# UNITED STATES PATENT AND TRADEMARK OFFICE

10/570,803

<b>Office Action Summary</b>	<b>Application No.</b> 10/570,803	<b>Applicant(s)</b> YOON ET AL.	
	<b>Examiner</b> GERARD T. HIGGINS	<b>Art Unit</b> 1794

## **DETAILED ACTION**

FIG. 1

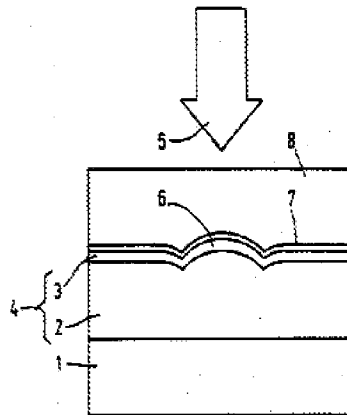
With regard to claim 1, Van Liempd et al. teach the device of Figure 1.

The device is comprised of a master substrate **1**, a heat absorption layer **2**, which is coated on the master substrate and absorbs heat irradiated from a beam **5**, and a separation layer **3**, which is coated on the heat absorption layer (col. 5, lines 12-35). It is clear from the Figure that the light absorbed from the laser beam heats up either the heat absorption layer **2** or the separation layer **3** and a volume change occurs, which is the bump **6**.

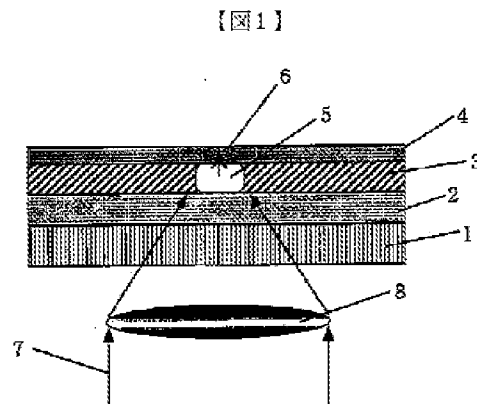
With regard to claim 1, Kuwabara et al. disclose an optical master disc [0002] of the structure in Figure 1.

The device is comprised of a master substrate **1**, a heat absorption layer **3**, a protective dielectric layer **2**, and a separation layer **4** [0011]. The heating of the light-to-heat absorption layer will transfer that heat to the separation layer as is seen in the Figure. This will inherently result in a volume change in at least one of the separation layer or the heat absorption layer.

*FIG. 7*

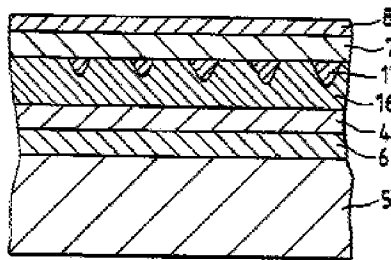
With regard to claim 1, Terao et al. disclose the device of Figure 7.

The optical medium of their invention may be considered a recorded master because the information contained within the recording layer may be reproduced and reused in the manufacture of an information storage medium (i.e. mp3 files). The device is comprised of a master substrate **8**, a heat absorption layer **16**, which is on the master substrate, and a separation layer **5** (col. 8, line 64 to col. 9, line 10 and col. 13, lines 17-36). The layer **16** has recorded data on the bumps or dents of the layer **16**, providing discrete data points.

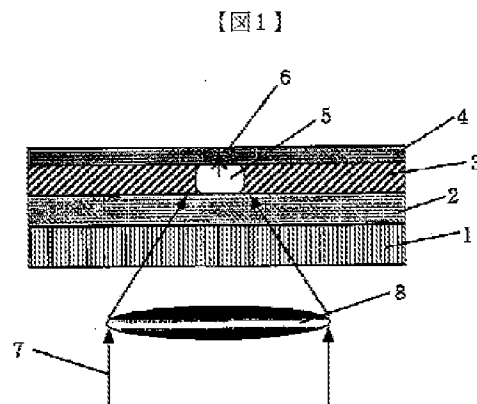
Kuwabara et al. disclose an optical master disc [0002] of the structure in Figure

The device is comprised of a master substrate **1**, a heat absorption layer **3**, a protective dielectric layer **2**, and a separation layer **4** [0011]. The separation layer is a photoresist [0015], the heat absorption layer is an alloy [0018], and the protective layer may be a ZnS-SiO<sub>2</sub> dielectric [0020].
